Water Quality Technical Memorandum Addendum

New Pueblo Freeway Phase 1

CDOT Project No. IM 0251-156

Colorado Department of Transportation

Exhibit 1 - Phase I
Northern Avenue

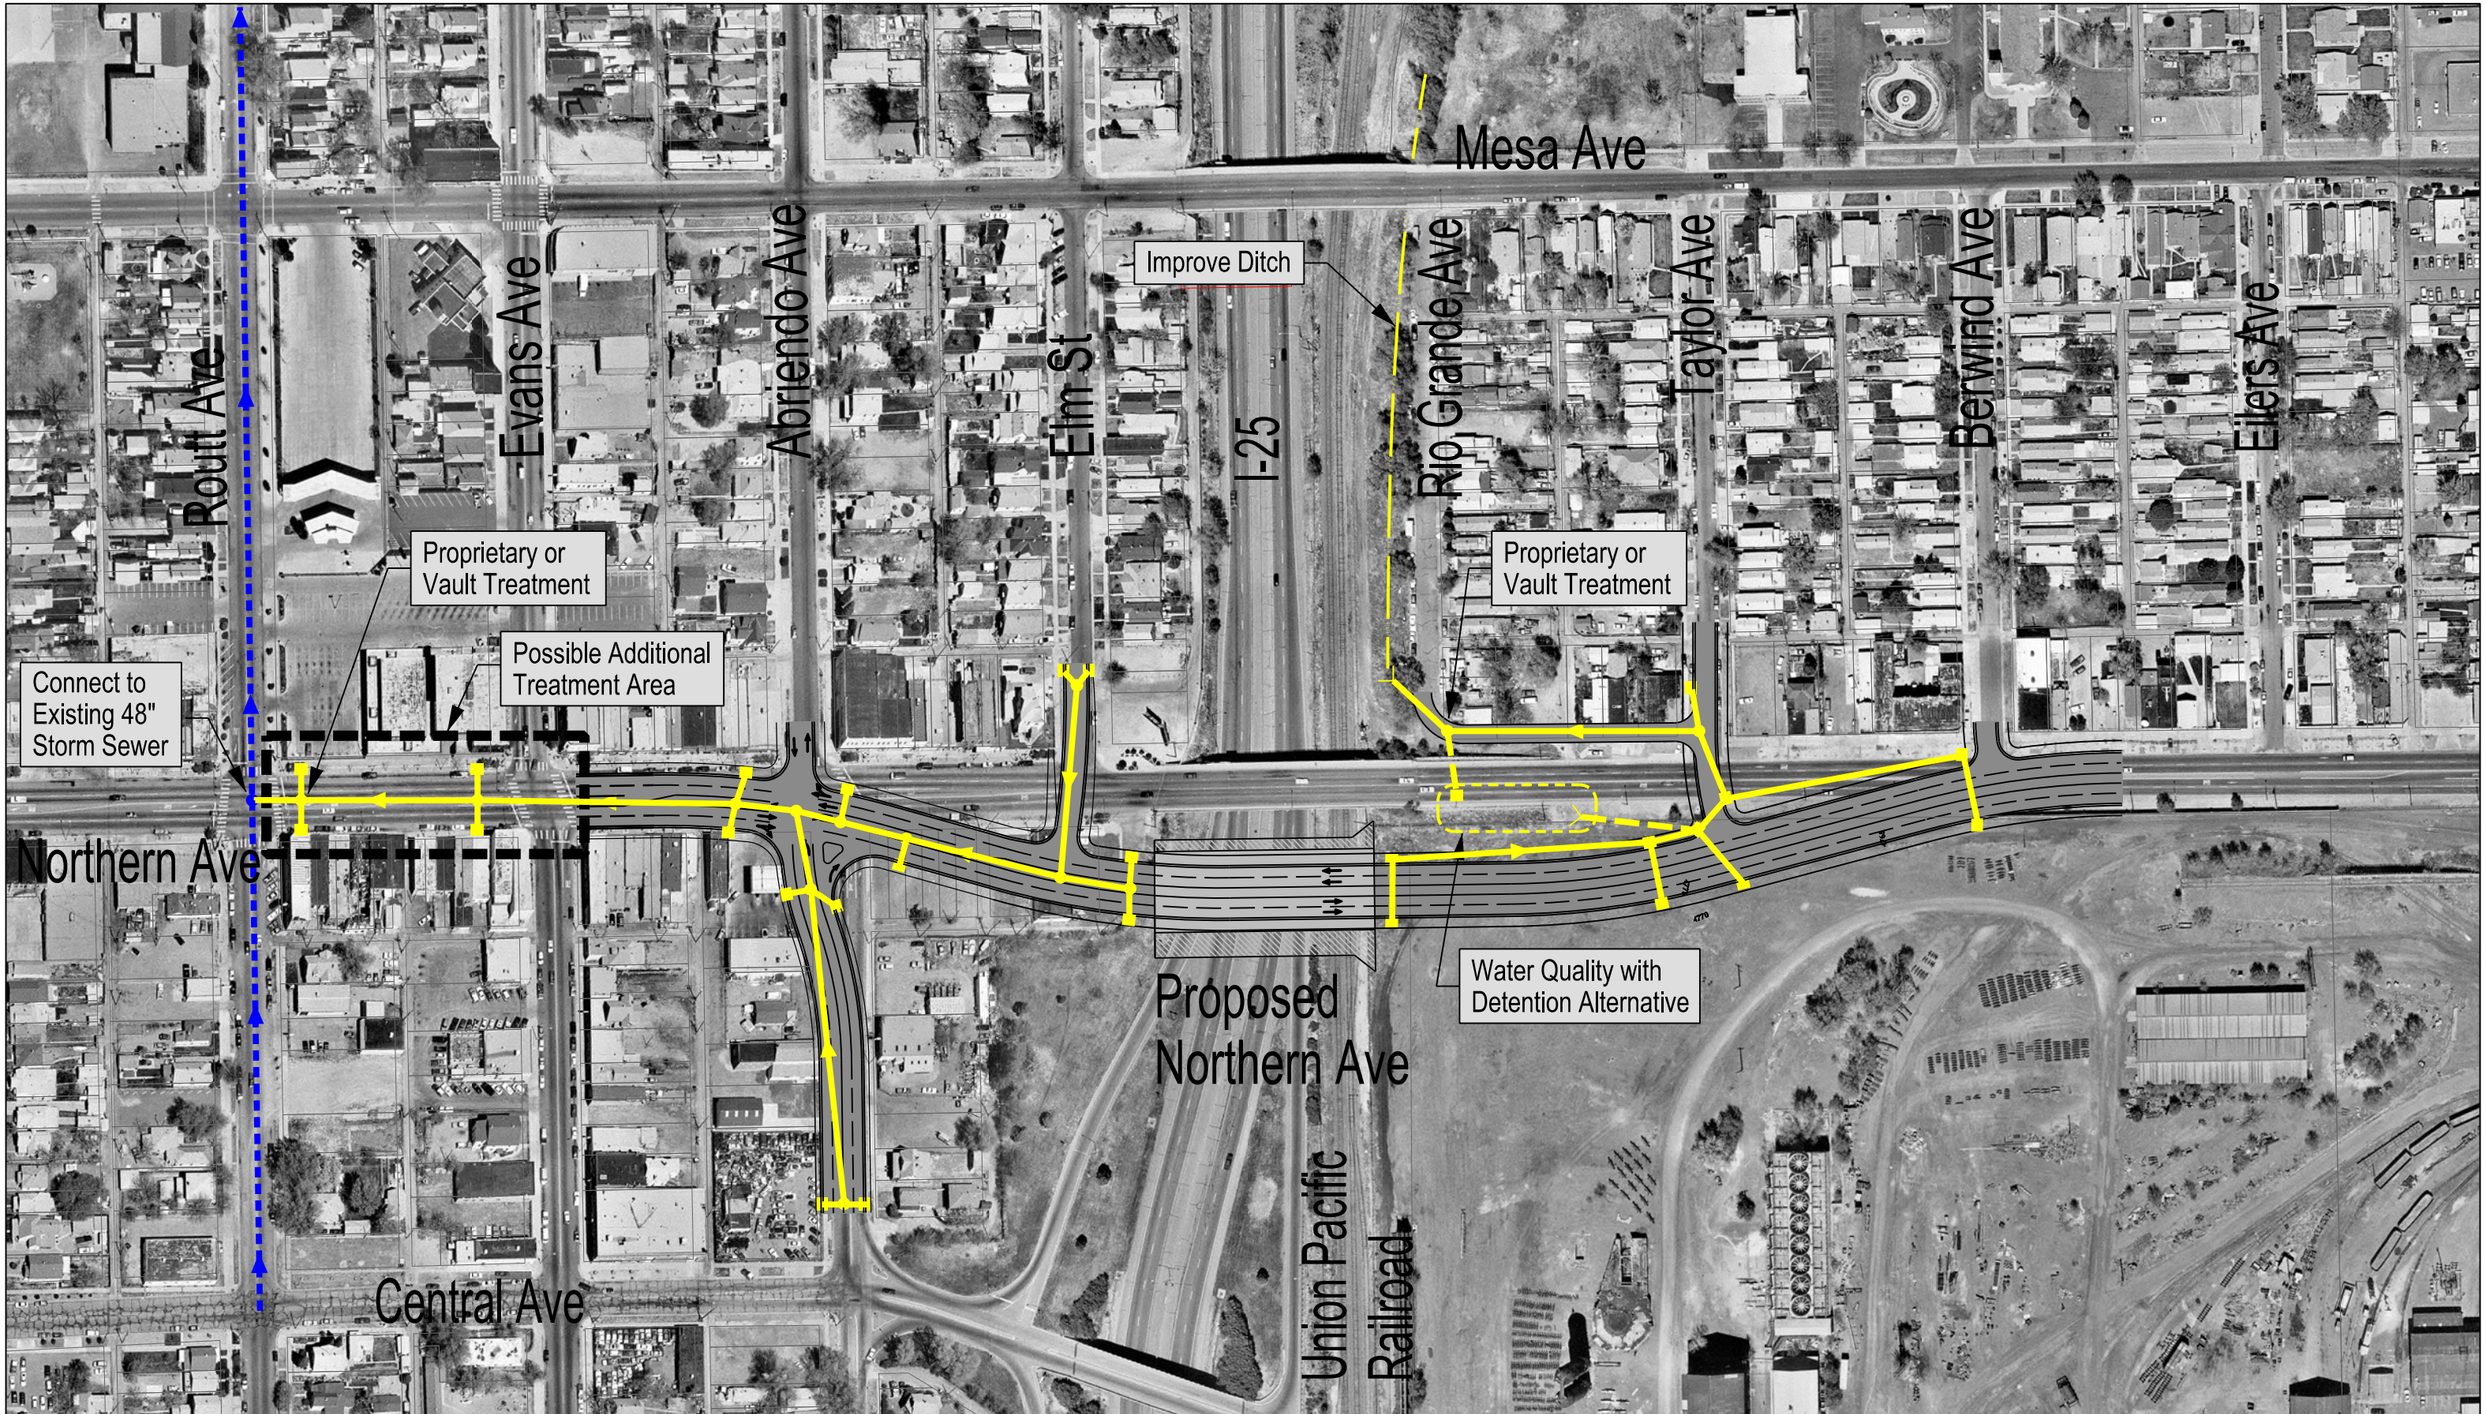
The Northern Avenue Bridge project is within the Pond 4A and 4B onsite basin areas. The conceptual design consists of the pond locations and approximately 4,000 feet of storm drain system discharging north into the Arkansas River. Neither of the ultimate ponds 4A and 4B would be constructed in Phase I because Interstate 25 (I-25) will not be relocated until the ultimate project is constructed. In the Phase I interim condition, storm drains would be constructed within Northern Avenue on each side of the proposed bridge over I-25.

The west-side storm drain would convey runoff to an existing storm drain running north under Routt Avenue. Water quality would be provided by proposed proprietary facilities located immediately upstream of the existing Routt Avenue drain. The proprietary system could also treat runoff from the section of Northern Avenue located just west of the project limits between Routt and Evans Avenues. Credit for this treatment of non-project runoff could be applied to compensate for other project areas that may prove impractical to treat.

The proposed storm drain on Northern Avenue east of I-25 would discharge to an existing swale to the east of the Union Pacific Railroad (UPRR) near I-25. This swale along the east side of the UPRR would need to be deepened to accept runoff originating from Northern Avenue east of Taylor Avenue. Discharge to the swale would require an agreement with the railroad. Because a wider Northern Avenue would create more runoff into the swale, an agreement with the railroad may require construction of a detention pond. Should detention be required, a pond would be constructed within the existing Northern Avenue alignment between Rio Grande and Taylor Avenues.

A proprietary or vault system would still be needed to treat runoff from the proposed frontage road connecting Rio Grande Avenue to Taylor Avenue. The frontage road storm drain would release into the ditch along the UPRR. Again, use of the ditch would require an agreement with the railroad. The interim elements could be incorporated into the ultimate outfall system.

Exhibit 2 - Phase I
Ilex Avenue

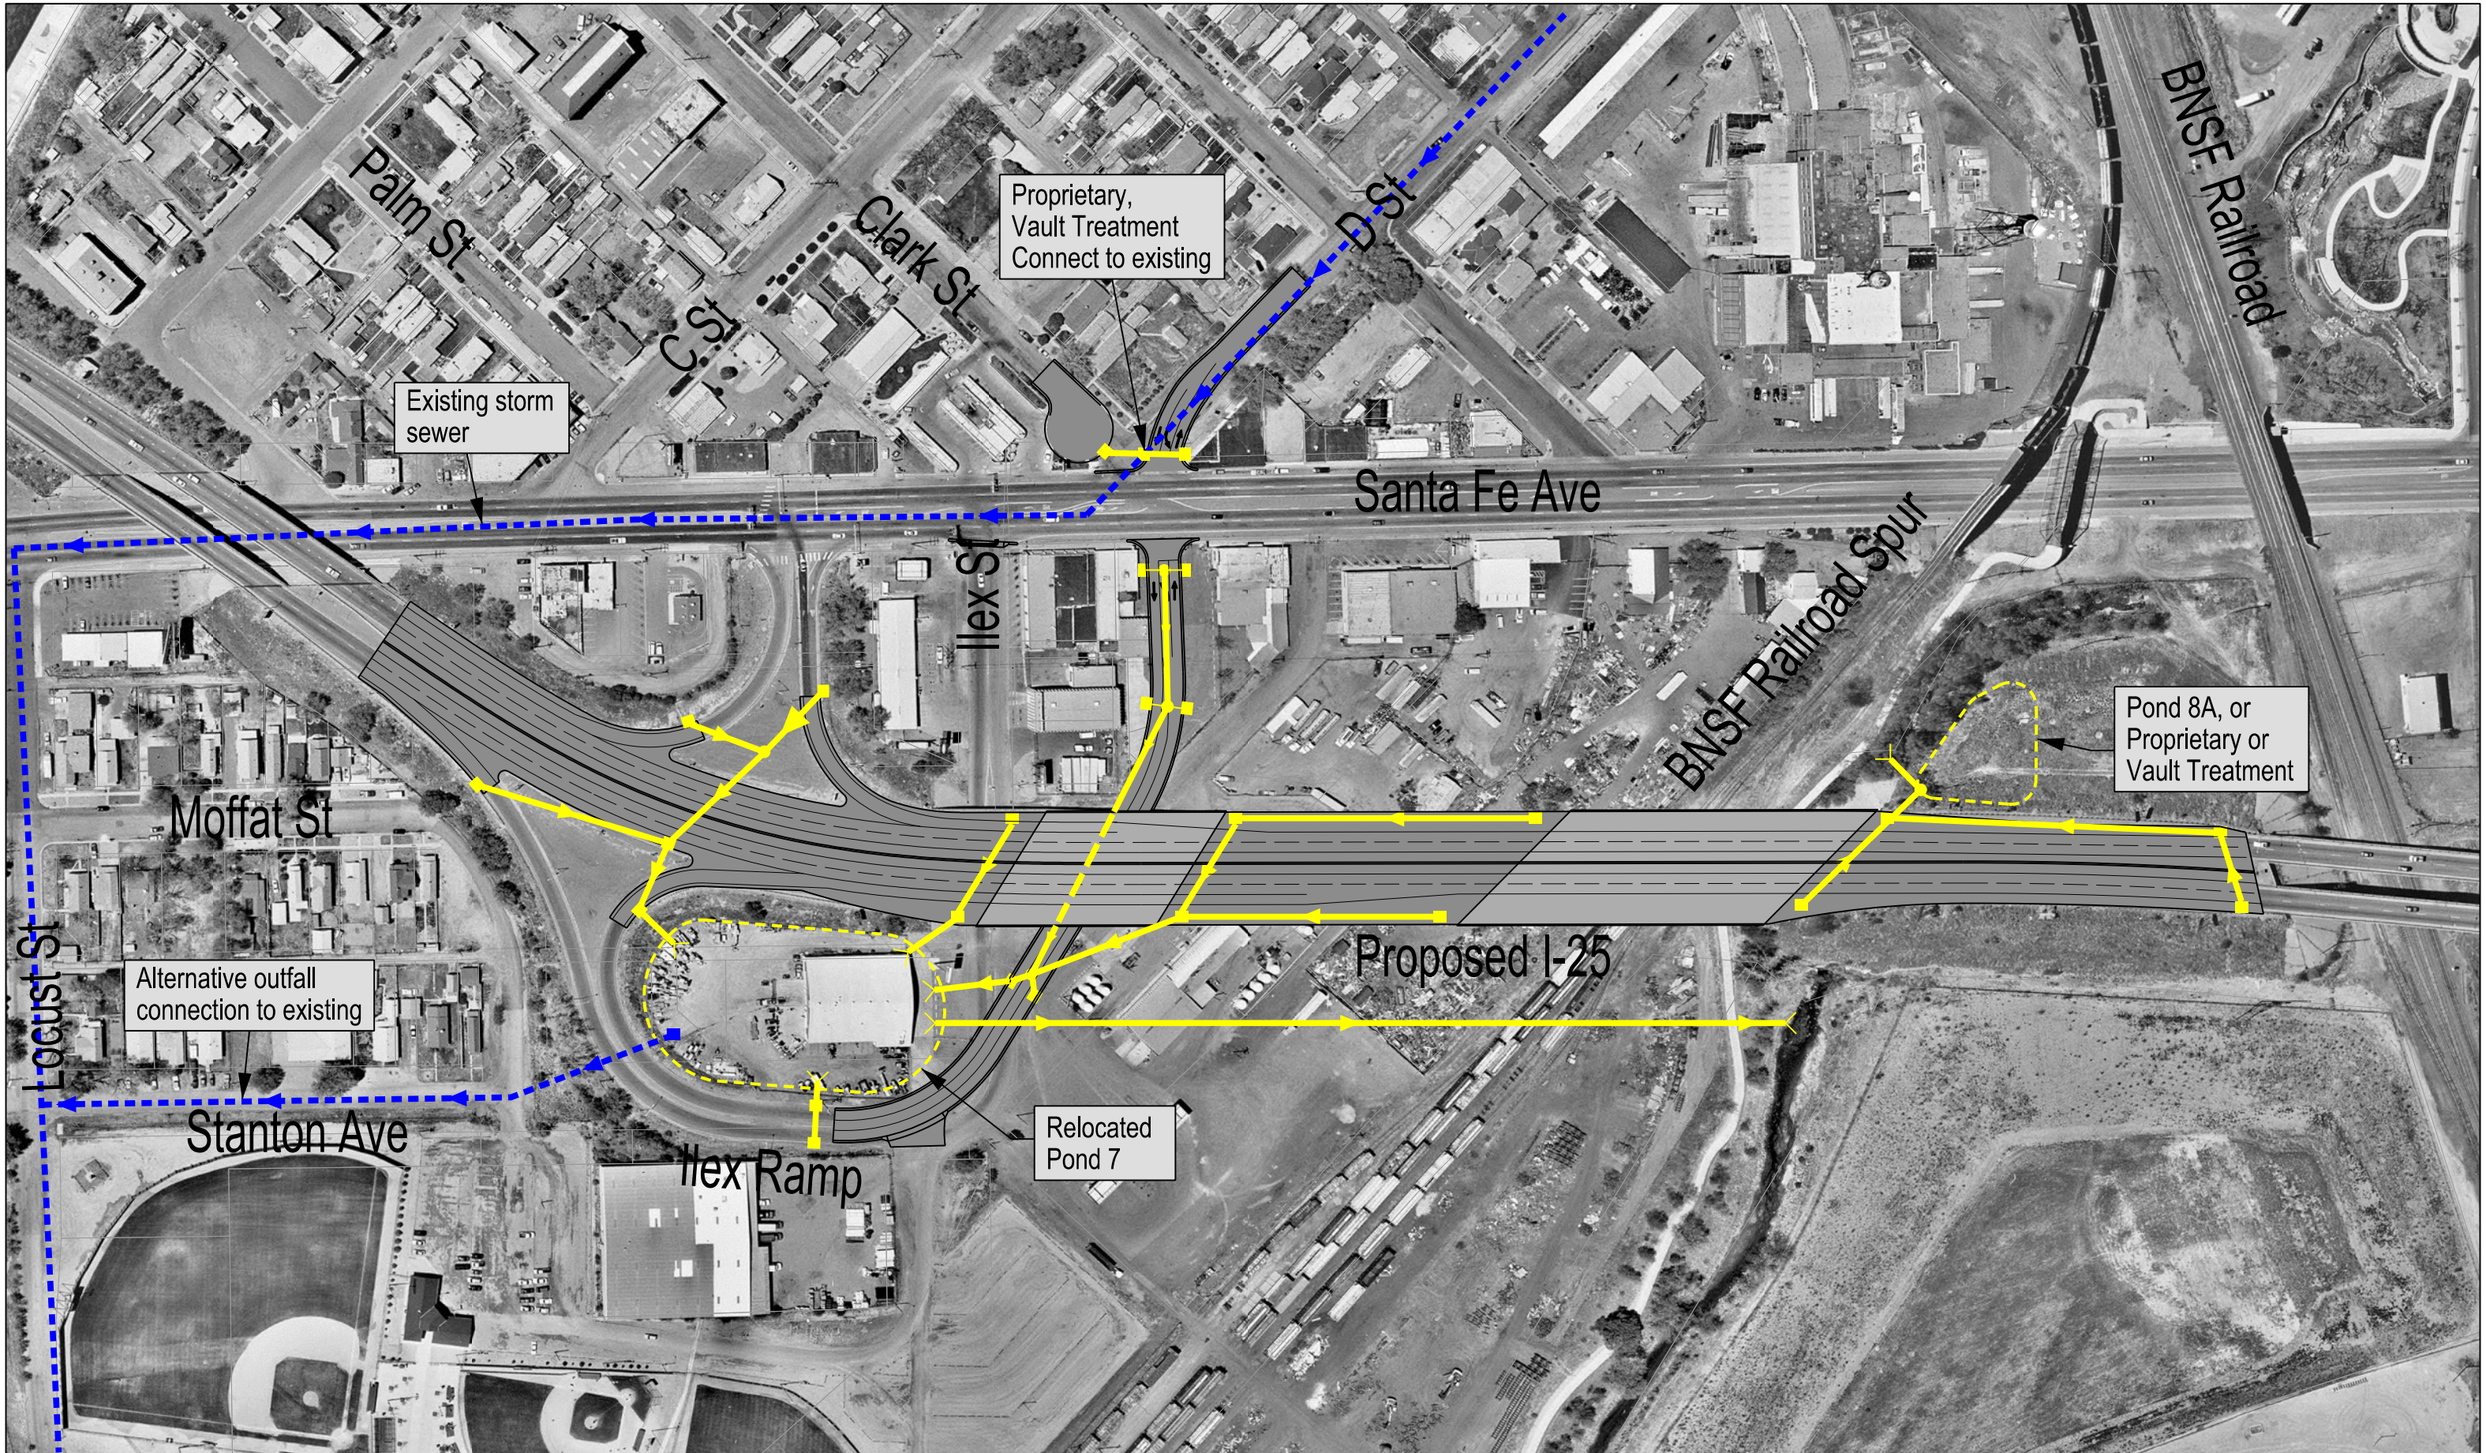
The Ilex Avenue Bridge project is within the Pond 7 and 8 onsite basin areas. The original location for Pond 7 is not feasible with the modified alignment. Existing I-25 will remain in place on the original Pond 7 site through the Phase I construction period. Pond 7 is proposed to be relocated to the infield area of the Ilex Ramp.

Pond 8A would be constructed north of the Burlington Northern Santa Fe (BNSF) railroad spur between I-25 and Santa Fe Avenue. If the site should prove too steep to place a pond, a proprietary or vault system could be used. This system would discharge into the Arkansas

River tributary (the river's historic alignment), which flows parallel to the railroad spur and into Runyon Lake.

Pond 8, which was to be located east of I-25 between the BNSF railroad spur and the Arkansas River tributary, is not likely to be feasible because the required pipe below the railroad spur would be too low to outlet into the Arkansas River tributary. The relocated Pond 7 would discharge to the tributary north of the BNSF railroad spur via approximately 1,000 feet of storm drain. Alternatively, the relocated Pond 7 could discharge into a new storm drain that would be constructed within Stanton Avenue. This storm drain would convey flow south and connect to an existing storm sewer in Locust Street.

Drainage from D Street and Clark Street west of Santa Fe Avenue would be treated using a proprietary system prior to discharging into the existing Santa Fe Avenue storm drain.
